From: [Eli Z Tsarovsky](#)
To: [Plan Commission Comments](#)
Subject: Plan Commission - 12.12.22 - Agenda Items 6-8
Date: Monday, December 12, 2022 9:27:37 AM
Attachments: [Lake Street Garage Committee Report \(1\).pdf](#)

My name is Eli Tsarovsky and I am the President of the Campus Area Neighborhood Association. I am emailing you all today in opposition to the current plans for the 415 N Lake Street Redevelopment in the 2nd Ald. Dist.

Lake Street Garage Steering Committee Report

November 21st, 2022

Alternate Layout

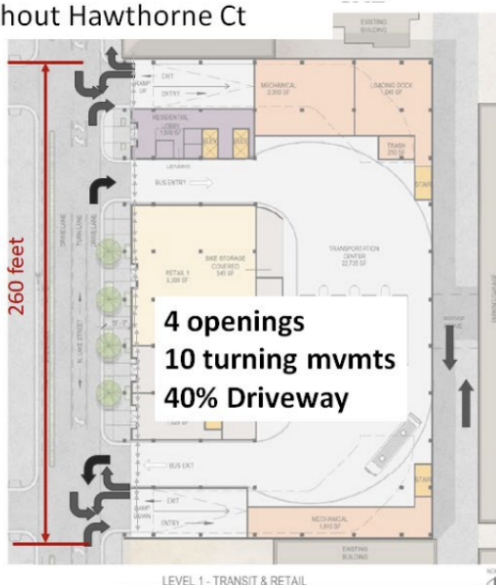
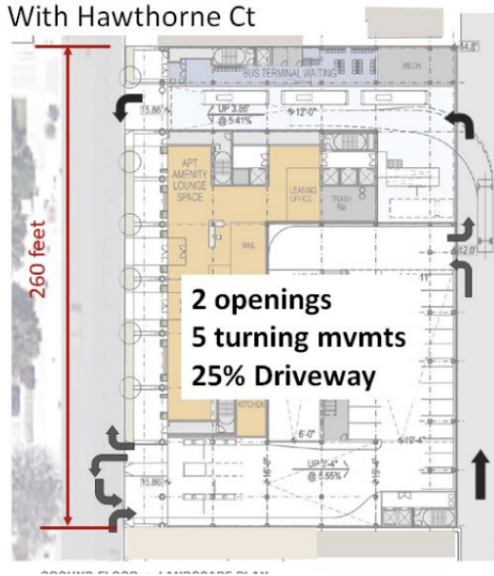
The traffic flow of the current proposal requires intercity buses to cross important, busy lanes of traffic that include **the Major BRT (Bus Rapid Transit) Lane, the unprotected Bike Lane, and the Major Sidewalk**. This is a major logistical flaw as this presents lots of opportunities for major backups on University Ave due to buses not being able to cross the lanes of traffic and a higher risk of accidents due to the Hawthorne Ct functioning as an alleyway and not being a controlled intersection. Not to mention University Ave is a much faster street than Lake Street and increases the risk of accidents like fender benders and bikers being hit during rush hour traffic. The development needs to use Lake Street for buses because it is a controlled intersection with a stoplight as compared to the Hawthorne Ct entrance which has no traffic signals. Additionally, the East Campus Mall BRT Spot can be inferred as a major bus stop for students commuting across campus. The three major residence halls are within a couple of blocks of this spot. Blockages at the Hawthorne Ct entrance will disrupt this major BRT system hub.

The three spots for buses seem inadequate and are shortchanging the intercity bus station potential. The bus terminal ought to have five bays like the old bus terminal and there needs to be a better plan for staging. They are trying to do too much at once and seem to be modeled after La Crosse without consideration of the unique challenges of this area. The Bus terminal is different and you can drive straight through it. This design

seems too complex at the moment. The proposal does not seem to completely address everything. The entrances for residential parking are on the same side as the Van Galder Bus entrance. This mix of traffic seems problematic with bus schedules and the residential experience. If there is a queue that wraps around the corner, this will affect the BRT lane and Metro Bus lane. There is also a need for more entrances and exits to accommodate queues during special events.

Without Hawthorne Ct

The alternative layout provided by the City of Madison Transportation Department

- Moving the entrances to the bus terminal and parking to Lake Street
- Creating a Transportation plan that considers all modes of transportation on the site
- Using this project to activate Hawthorne Court with public art, lighting, and cameras
- Make the bus terminal part of a covered part of Lake Street.
- We need a complete Traffic/Environmental Study that considers the impact on local businesses, existing apartments, and all current modes of traffic circulating through this site.
